Groundwater Transfer Review Summary Form

Transfer/PA # T- 13864

Application: T-13864

Applicant Name: Kreg Lindberg & Carissa Cousins

Transfer Map

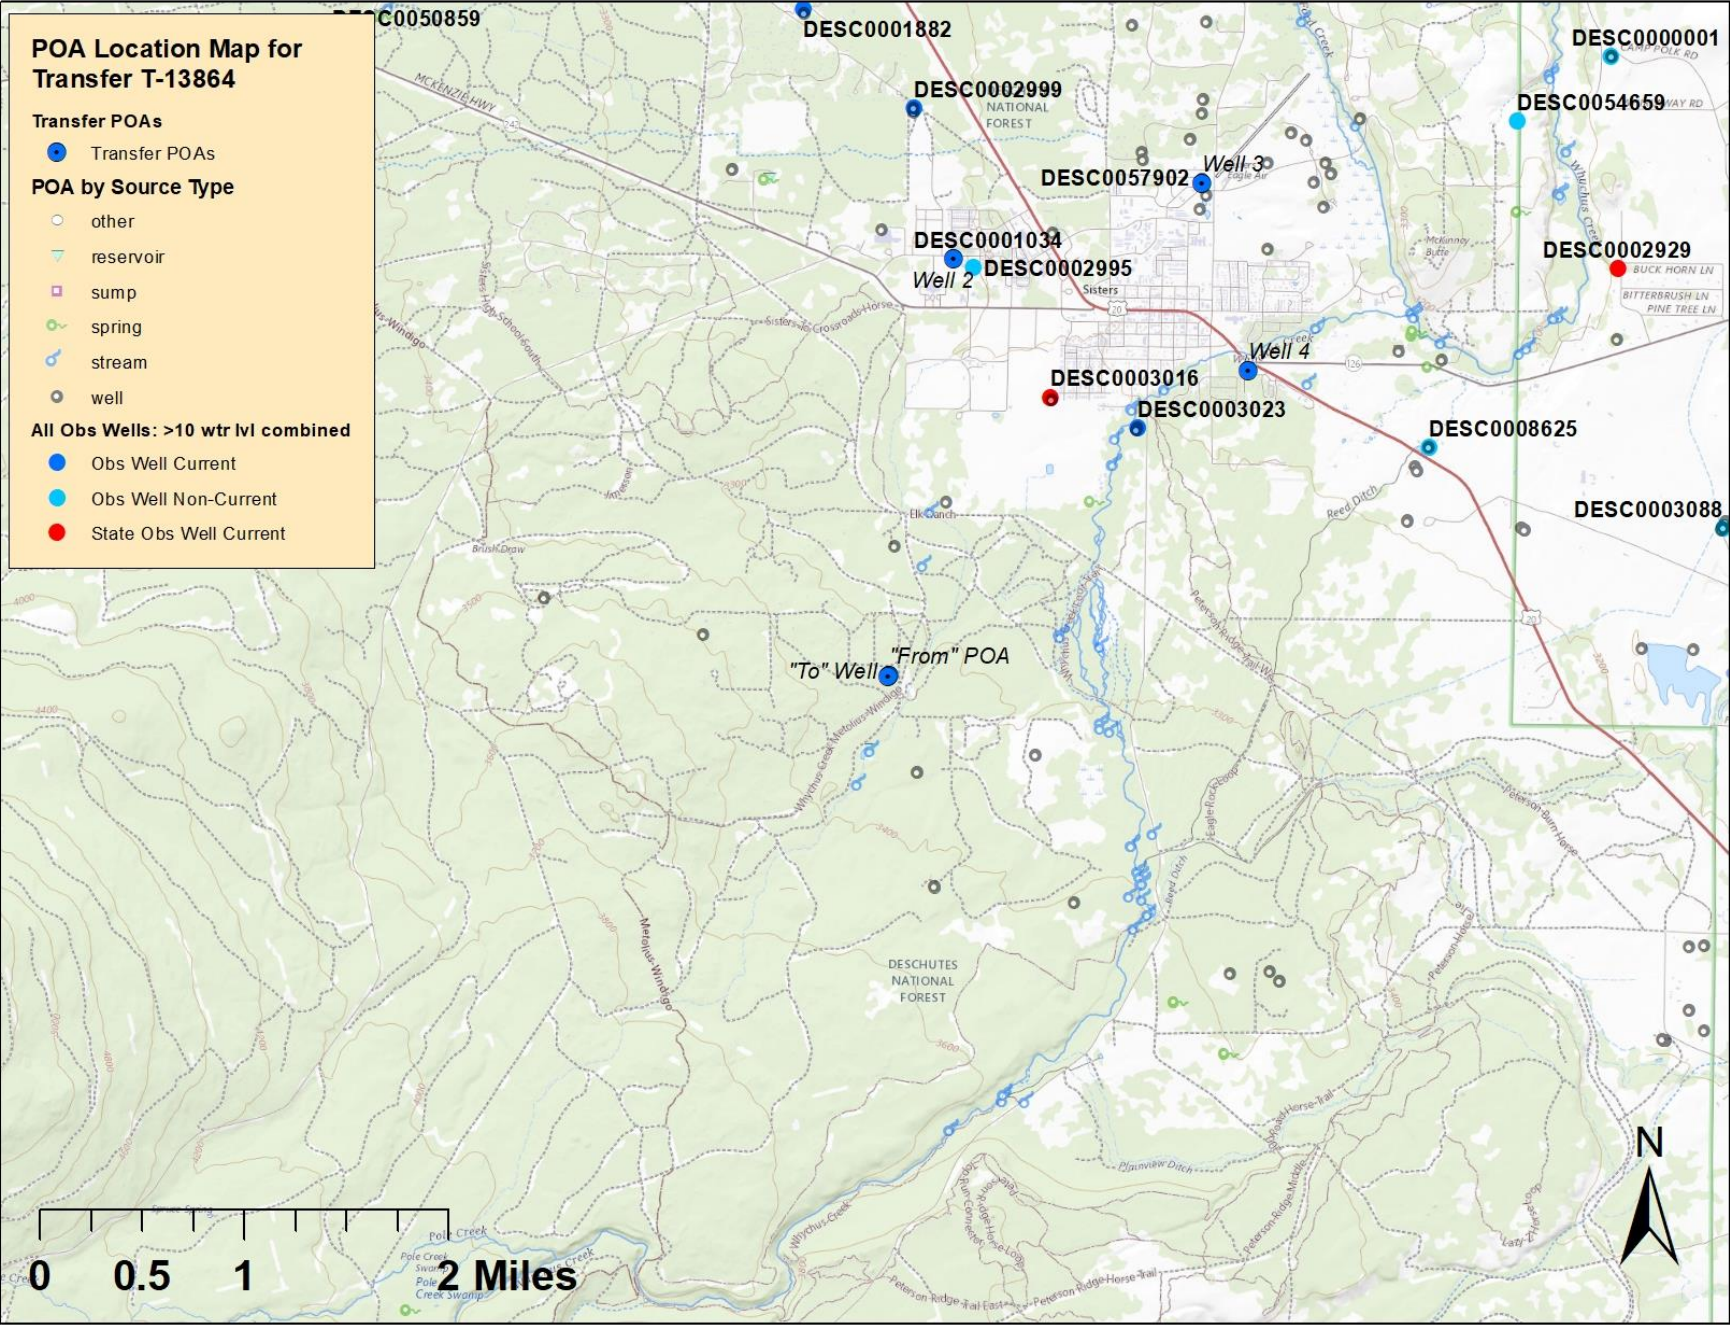
2. Will the proposed POA develop the same aquifer (source) as the existing authorized POA?
☒ Yes ☐ No Comments: DESC 3111 is located approximately 20 feet from DESC 61857 and drilled to similar depths within Cascade lavas and tuffaceous units.

4. a) Will this proposed change, at its maximum allowed rate of use, likely result in an increase in interference with **another ground water right**?
☐ Yes ☒ No Comments: The nearest possible groundwater user is 750-1000 feet to the south in the adjacent tax lot. Assuming no change in pumping patterns, the proposed change in POA location is not expected to produce a measurable difference in well-to-well interference.

☐ Yes ☒ No Comments: Considering the proximity of the “to” and “from” well, the proposed changes are not expected to measurably increase surface water interference.
